## MEMORANDUM

**Subject:** Response to JART comments and follow up to Feb. 16, 2022 meeting.

This technical memorandum is intended to address remaining concerns expressed in the February 16, 2022 meeting with the JART hydrogeology technical team. The meeting was convened to address the following outstanding items related to the infiltration feature that will be constructed prior to Phase 3 excavation in the proposed West Quarry extension.

Figure 9: Location of water quality sampling points.

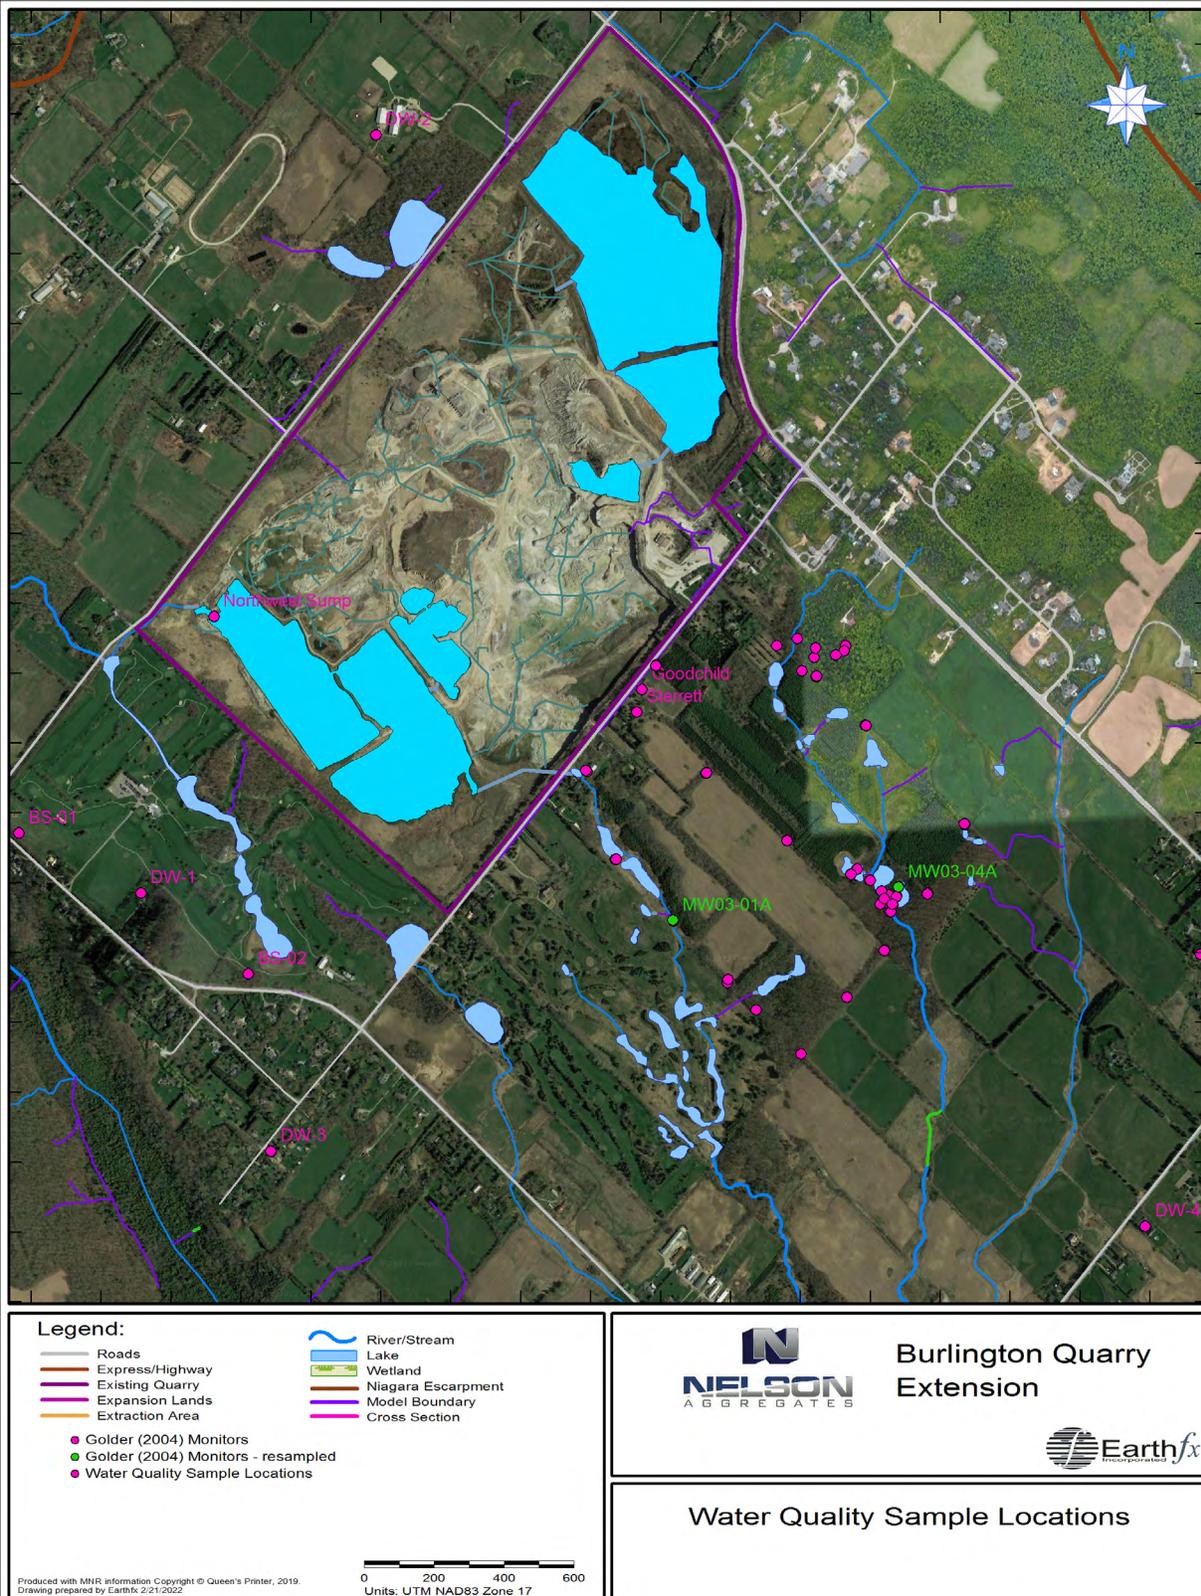
Additional sampling was conducted by Azimuth in 2019 for well clusters in both the west extension area and in the south extension area (Table 3). In a similar manner to the Golder results, exceedances are seen in the samples for hardness, TDS, iron, and manganese. The water chemistry at location MW03-01A (Figure 9, Table 3), immediately beneath the stream containing the south quarry discharge, is very similar to the chemistry at background location MW03-04A (Figure 9), which is located distant from the quarry and south quarry discharge. This data indicates that the south quarry discharge is not impacting the water quality relative to the background levels at the site. Complete results are shown in Table 4 and Table 5.

Background water quality in the west extension (without road salt impact) is better illustrated by the sampling at well DW1 (Figure 9). A number of domestic wells, the northwest quarry sump, and the golf course ponds were sampled in March and May of 2021 and analyzed for compliance with ODWO (Table 4). The samples for the sump and pond provide the most direct evidence that the quarry discharge is compliant with ODWO and should not be a concern for future infiltration. The Aesthetic Objectives for hardness and TDS are exceeded by all samples, with the sump and pond having the lowest values (The lower values are reflective of the mixing of groundwater inflows with direct precipitation into the quarry). DW1, located west of the golf course ponds, shows no effect of the ponds and good water quality. (DW3, located east of the quarry, appears to have been impacted by road salt.)
